2 PROPOSED MODIFICATION

Tritton is proposing to further modify its development consent under Section 75W of the *Environmental Planning and Assessment Act 1979* (EP&A Act). The proposed modification (DA41/98 MOD 5) involves:

Figure 3: Proposed Enlarged Waste Rock Emplacement

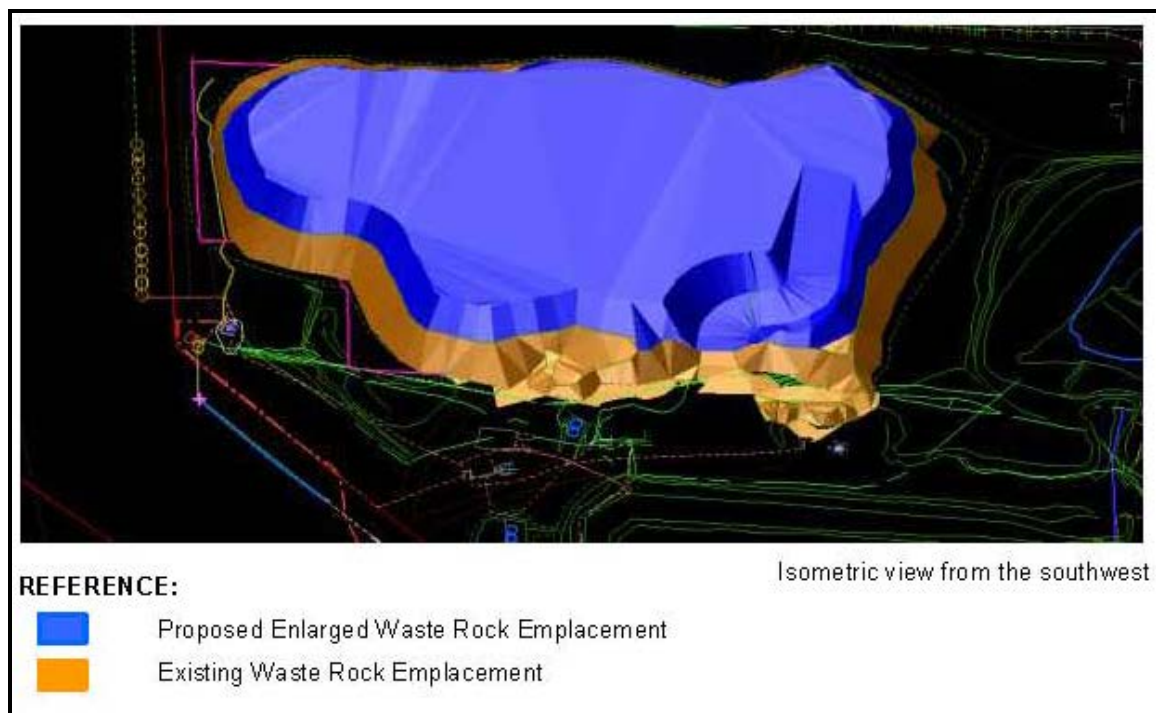
However, increasing the use of pastefill in the underground workings has resulted in more NAF waste rock requiring surface emplacement. Tritton is therefore seeking to increase capacity of its NAF waste rock emplacement, by increasing the allowable final height of the emplacement from 10 m to 20 m above the ground surface. This increase would allow an additional 350,000 m³ of NAF waste rock to be emplaced, sufficient for a further approximately two years of mining operations. Further emplacement of NAF waste rock following this period would be considered in conjunction with a proposed review of future mining operations during the two year period.

The footprint of the existing emplacement would not increase (see Figure 3).

Bogan Shire Council (Council) recommended that transportation be restricted to 7.00 am – 10.00 pm, that the increased waste rock emplacement is designed to minimise visual impacts, and that adequate mitigation measures are implemented to manage water quality, air quality, and acid mine drainage.

Department of Primary Industries (DPI) including the NSW Office of Water (NOW) supports Tritton's commitments and mitigation measures regarding the rehabilitation of the waste rock emplacement. NOW recommended that the current Surface Water Management Plan is updated to ensure adequate sediment and erosion controls are in place at the expanded waste rock emplacement.

Tritton would initially construct the north western and north eastern faces of the emplacement area, which would then act as a noise barrier to provide further acoustic attenuation of the emplacement activities at receivers north of the mine. To further minimise noise impacts, Tritton has committed to only developing the north western and north eastern faces of the emplacement area during daylight hours.

The elevated emplacement would also not be visible from residences. However, the users of Yarrandale Road would be subject to additional impacts. Tritton would mitigate potential visual impacts with progressive rehabilitation and planting vegetation on the lower sections of the emplacement area. The early development of the sections of the emplacement facing Yarrandale Road would limit the direct visibility of the headlights from vehicles working on the waste rock emplacement to the travellers on the road.

The Department considers that the proposed modification would not significantly increase the visual impacts of the emplacement area, given that it would not be visible from any surrounding residences. Although the elevated emplacement area would be more visible from Yarrandale road, these impacts would not be significant given the small amount of non-project related traffic using the road and that passing motorists would only view the emplacement area for a very short period of time. Additionally, the Department notes that any impacts would reduce overtime as the waste rock emplacement area is rehabilitated and that the current approval requires Tritton to revegetate all disturbed areas as soon as practicable following construction.

The Department is satisfied that the existing conditions of approval allow the effective mitigation and management of visual impacts of the increased emplacement area.
